**TOWN OF NISKAYUNA
Conservation Advisory Council**

**TOWN OF NISKAYUNA
CONSERVATION ADVISORY COUNCIL**
Meeting Minutes
August 2, 2023
(Virtual) Google Meet

ITEM TITLE: EAF 2023-06: 2837 Aqueduct Rd. (Rivers Ledge) – Phase II site plan app for a building containing 55 senior apartments and 2,000 sq. ft. of mixed-use commercial space.

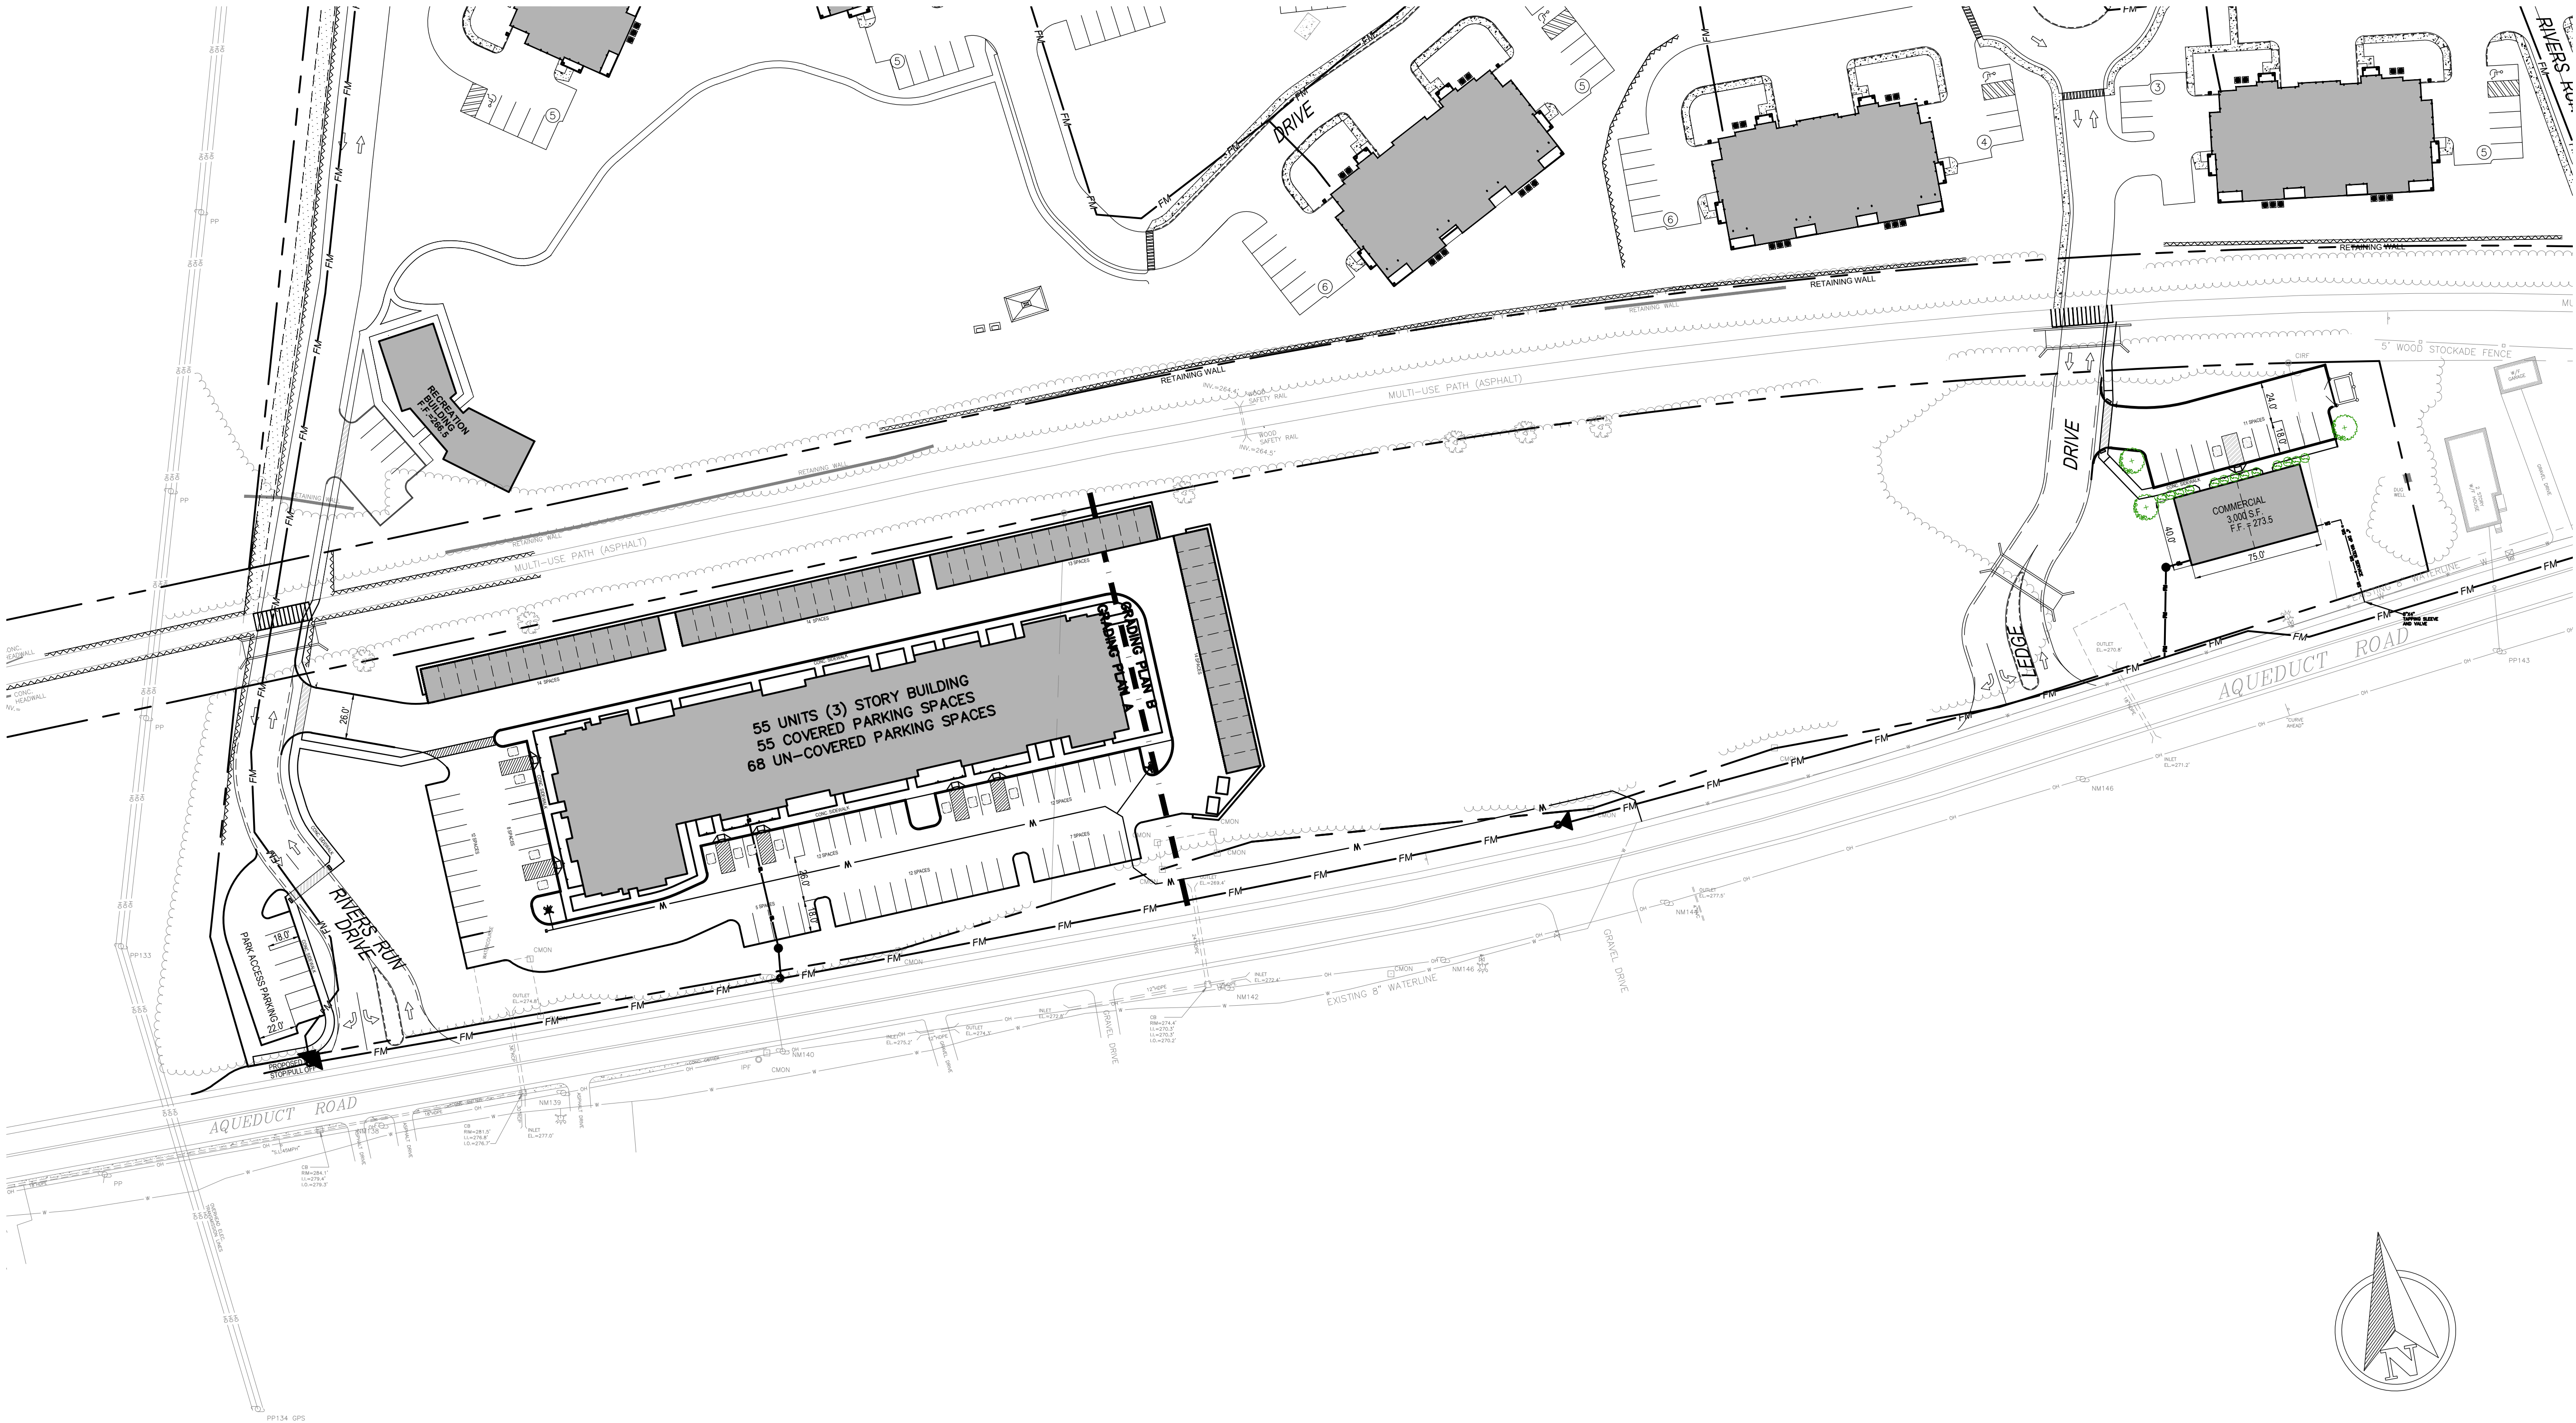
The PB should carefully review the new site plan drawing and photo renderings relative to the design requests that have been made by the PB, CAC and ARB at previous board meetings that include but are not limited to the following.

1. Add an outdoor seating / dining area – possibly between the Sr. Center Building and River Run Drive.
2. Explore transit opportunities / bus stop on premises.
3. Break up the sea of asphalt around the Sr. Center building
4. Show that the inside includes entrances and exits that are conducive to walking to the covered parking garages. Consider covered walkways from the building to the garages.
5. Include setback dimensions from the proposed garages to the property lines.

ARB COMMENT 8/16/23

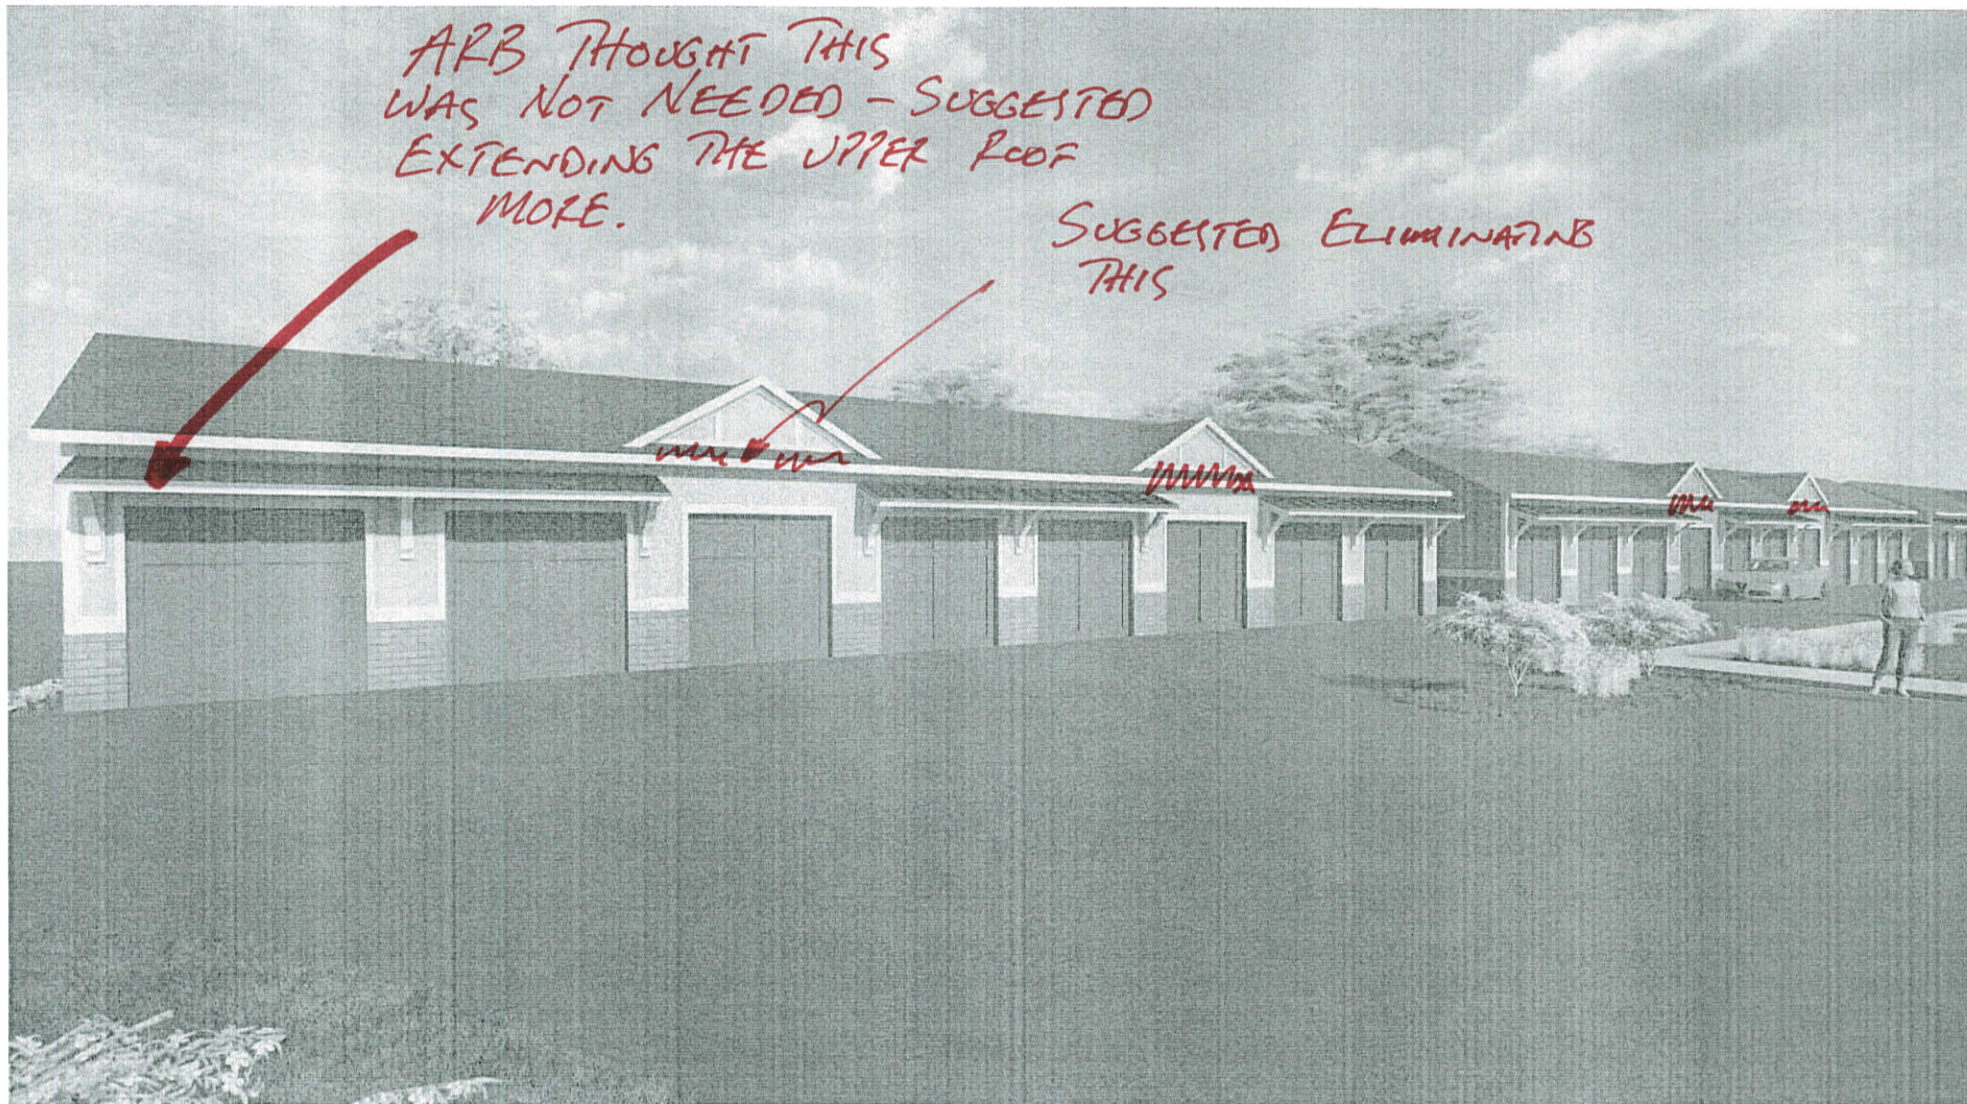
8/16/23 Architectural Review Board (ARB) meeting – The ARB reviewed the new files and documents. They were pleased with the overall appearance of the buildings and the surrounding landscaping. They provided Mr. Steenburgh with a marked up rendering and recommended

removing the courses of shingles under the gable roof portion of the garage. They also recommended that the gable feature be carried over to the back of the building.
